PRODUCT CHANGE NOTIFICATION

PCN No.: PCN-202512-059	**PCN Doc No.:** EC-20251226-PCN-04	**Date Issued:**	12/26/2025
Part Number or Series: PH1-XX-TB		**PCN Effective Date:**	12/26/2025
Customer: (If applicable)		**P/O No.: (If applicable)**	Not affected
Type of Change:	■ Mfg location Change / Qualification / Country of Origin (COO) ■ Design Change / Data Sheet Spec Change	**Last Time Buy Date:**	Not affected
Traceability Marking/Date code: No change		**Last Time Ship Date:**	Not affected
Replacement Part Number: PH1-XX-TB-HT-Y		**Sample Availability Date:**	Not affected

China Part

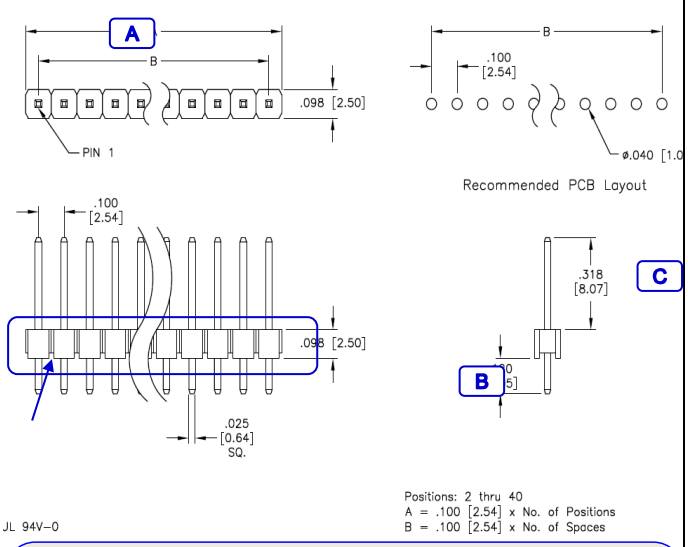
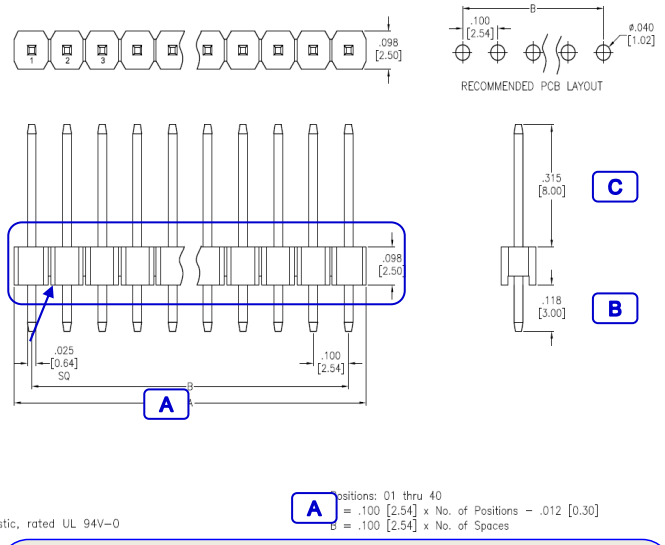
Impact of Change: P/N change, There are slight differences in appearance and size;	**Original COO parts still available:** Yes ☑ No ☐

Before the change:
1、Appearance ~ As shown in the above picture;
2、Size:
A) A=.100[2.54] x No. of Positions
B) 3.05mm C) 8.07mm

After the change:
1、Appearance ~ As shown in the above picture;
2、Size:
A) A=.100[2.54] x No .of Positions -.012 [0.30]
B) 3.00mm C) 8.00mm
